MIL-R-23285B
AMENDMENT 6
7 July 1994
SUPERSEDING
AMENDMENT 5
5 August 1975

RESISTORS, VARIABLE, NONWIRE-WOUND
GENERAL SPECIFICATION FOR

This amendment forms a part of MIL-R-23285B, dated 13 September 1967, and is approved for use by all Departments and Agencies of the Department of Defense.

FIGURE 6. Derating curve for high ambient temperatures. "

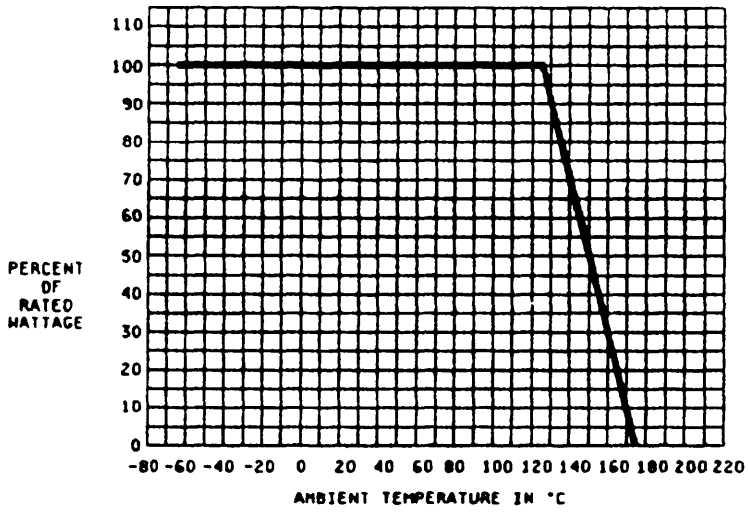
* FIGURE 6, delete and substitute:
